# CITY COUNCIL REGULAR MEETING

City Hall – Council Chamber  
405 Bagshaw Way, Edgewood, Florida  
Tuesday, March 15, 2022 at 6:30 PM

Date: March 7, 2022  
 To: City Council  
 From: Ellen Hardgrove, City Planning Consultant  
 Allen Lane, CPH Engineering, City Engineering Consultant  
 Jim Winter, CPH Engineering, City Landscape Architect Consultant  
 XC: Sandy Riffle, Interim City Clerk  
 Brett Sollazzo, Administrative Assistant  
 Drew Smith, City Attorney  
 Re: Mecatos Bakery and Café Site Plan/Waiver Application

This agenda item is for approval consideration of the site plan package for the Mecatos Bakery and Café that was submitted electronically to the City on February 28, 2022. The package includes the following

LANDSCAPE SITE PLAN FOR  
**Mecatots Cafe**  
 FLORIDA  
 EDGEWOOD

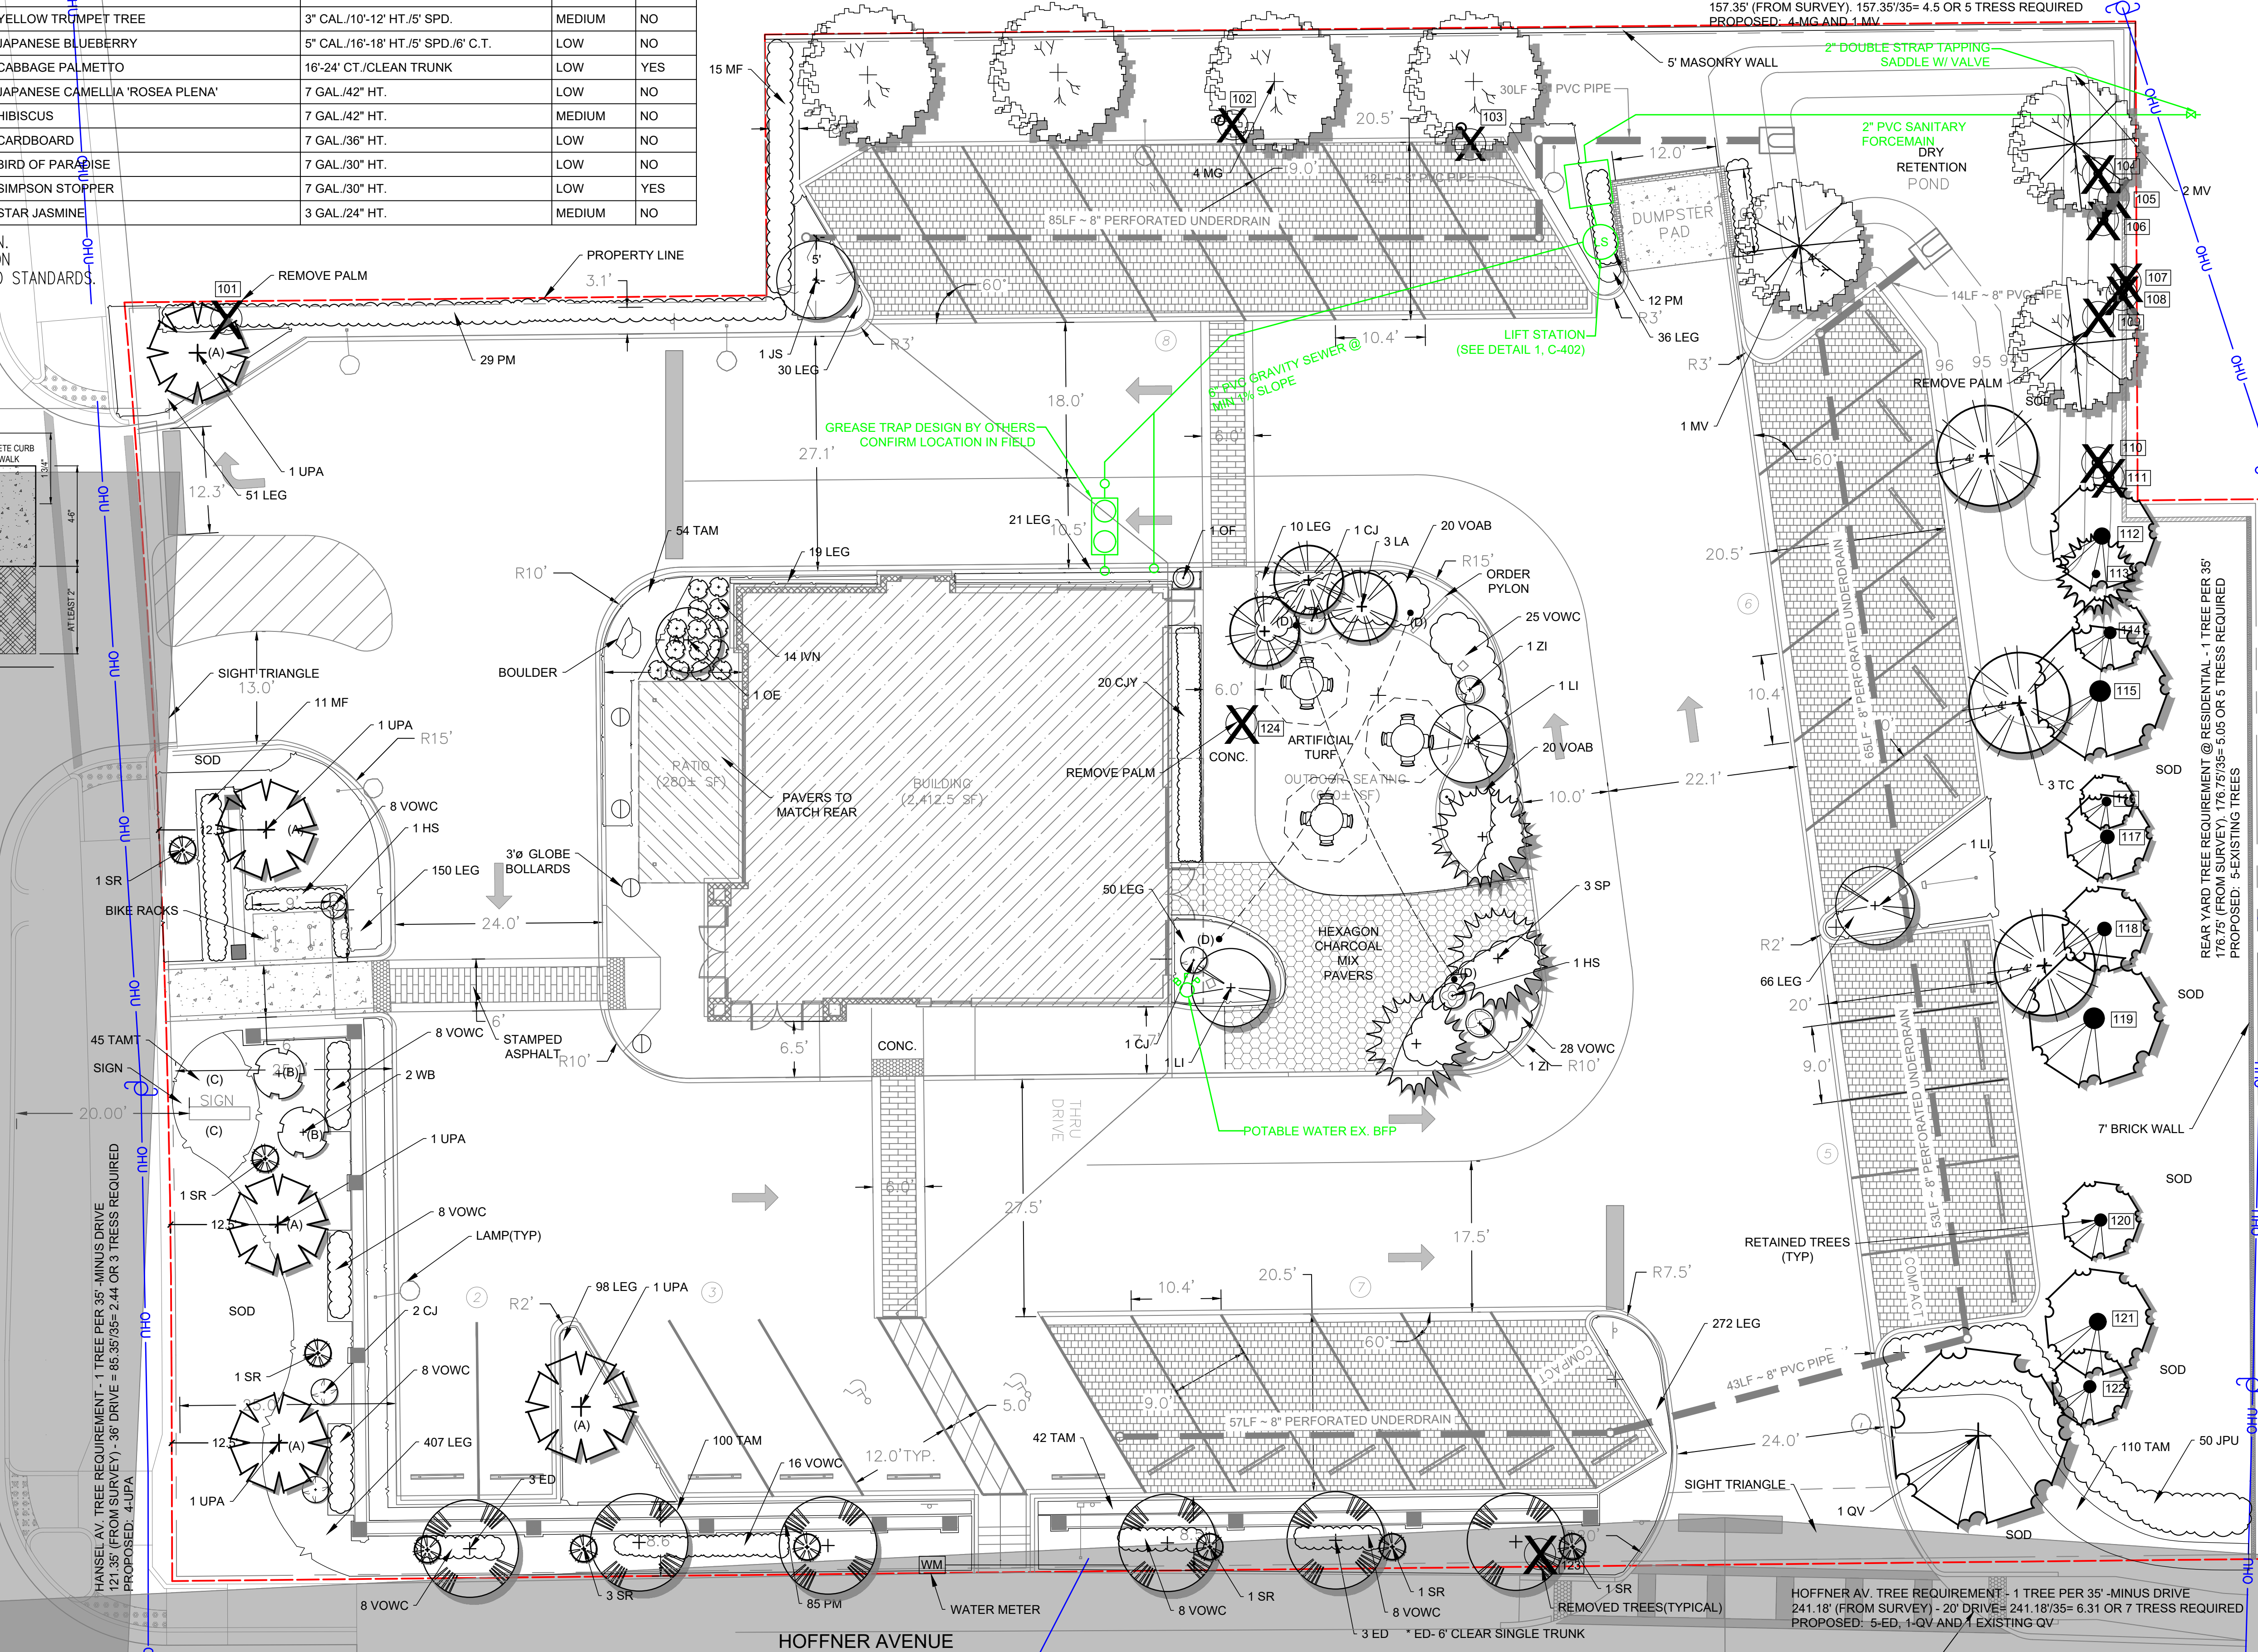
- 1) The submitted Landscape Plan shall be modified to include four (4) understory trees, evenly spaced, in front of the parking spaces west of the stairs shown as connecting to the sidewalk along Hoffner Avenue.

- 2) The submitted Landscape Plan shall be modified to include four (4) understory trees, evenly spaced, in front of the parking spaces between the stairs shown as connecting to the sidewalk along Hoffner Avenue and the Hoffner Avenue driveway. Adjustment in spacing near the existing light pole can be made with the approval of the City’s Landscape Architect.

- 3) The understory tree trunks shall be either 3” in caliper or multi-stemmed of at least three (3) stems each 1 inch caliper of the same variety.
- 4) The groundcover that will be used between the wall and the sidewalk along Hoffner Avenue needs to be identified by name and spacing and added to the plant table.

- 6) Provide the clear trunk measurement that will be maintained on the trees along Hoffner within the illustrated sight lines.
- 7) Replace the Bird of Paradise plants with a shrub that will not exceed the maximum height needed to maintain the driver sight distance.

- 8) Remove the note on the plan: “Hoffner Av. Tree Requirement – 1 Tree...”

If the waiver is approved,  
Resubmit a Landscape Plan which meets the minimum requirements of Code Chapter 114 as it relates to the vehicular use area adjacent to a public right-of-way to the satisfaction of the City’s Landscape Architect.
